# UNITED STATES PATENT AND TRADEMARK OFFICE

APPLICATION NO.	FILING DATE	FIRST NAMED INVENTOR	ATTORNEY DOCKET NO.	CONFIRMATION NO.
10/574,096	03/31/2006	Yasutsugu Muranishi	03865857498US	9785
23911 7590 02/23/2007 CROWELL & MORING LLP INTELLECTUAL PROPERTY GROUP P.O. BOX 14300 WASHINGTON, DC 20044-4300			EXAMINER SCRUGGS, ROBERT J	
			ART UNIT 3723	PAPER NUMBER

<b>Office Action Summary</b>	<b>Application No.</b>		<b>Applicant(s)</b>	
	10/574,096		MURANISHI ET AL.	
	<b>Examiner</b>		<b>Art Unit</b>	
	Robert Scruggs		3723

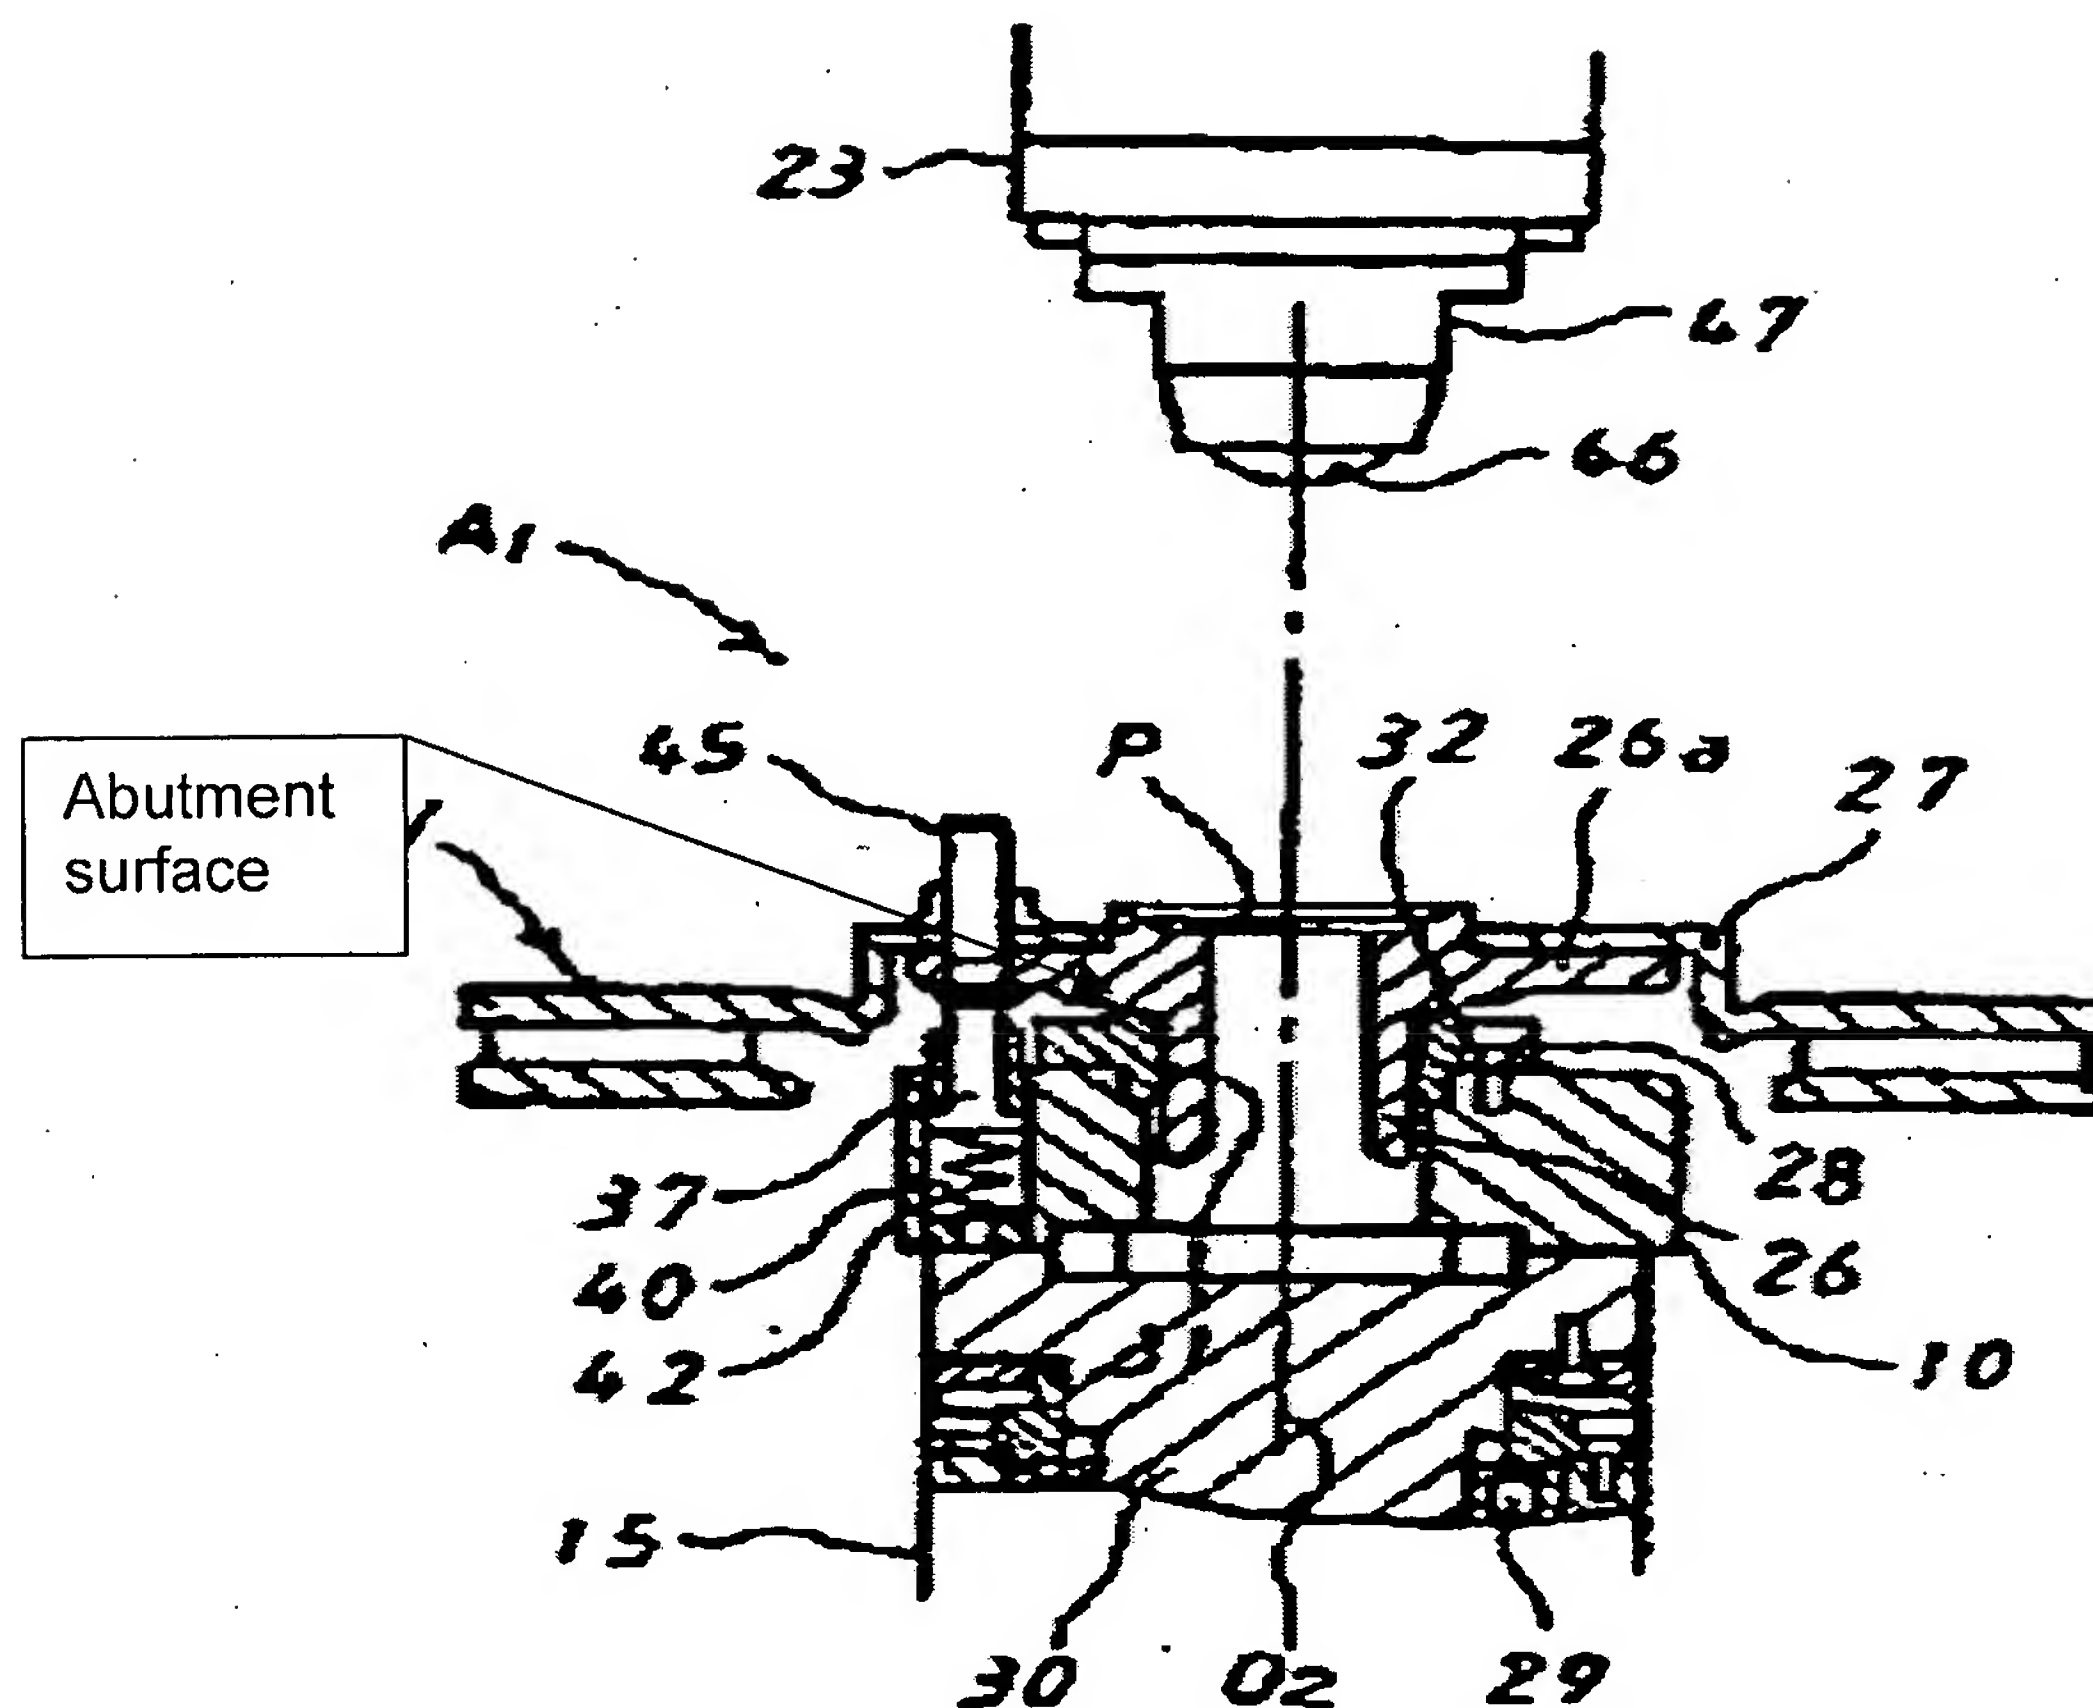
7. Claims 1-6 are rejected under 35 U.S.C. 103(a) as being unpatentable over Akiyoshi (JP-2004/050334) in view of Katsumi (cited by applicant). Akiyoshi clearly discloses the structural elements as claimed by the applicant, which includes a vertical duplex-head surface comprising, a work holding portion (10) including a first reference plane (31) coaxial with a self-rotating shaft (O2) and a second reference plane (32) perpendicular to the self-rotating shaft, the apparatus further includes upper and lower grindstones (2 and 3) and a clamping device (12) having a steel ball (23), but lacks, a method for dressing the above mentioned grindstones with a dressing tool including a fitting portion/cylindrical member designed to fit within the first reference plane and an abutment surface designed to abut against the second reference plane. However, Katsumi teaches of a method for dressing two vertically opposing grindstones with a dressing tool that can be formed with the same configuration as the work (see below), meaning that the shape of the dresser can be the same as the work.
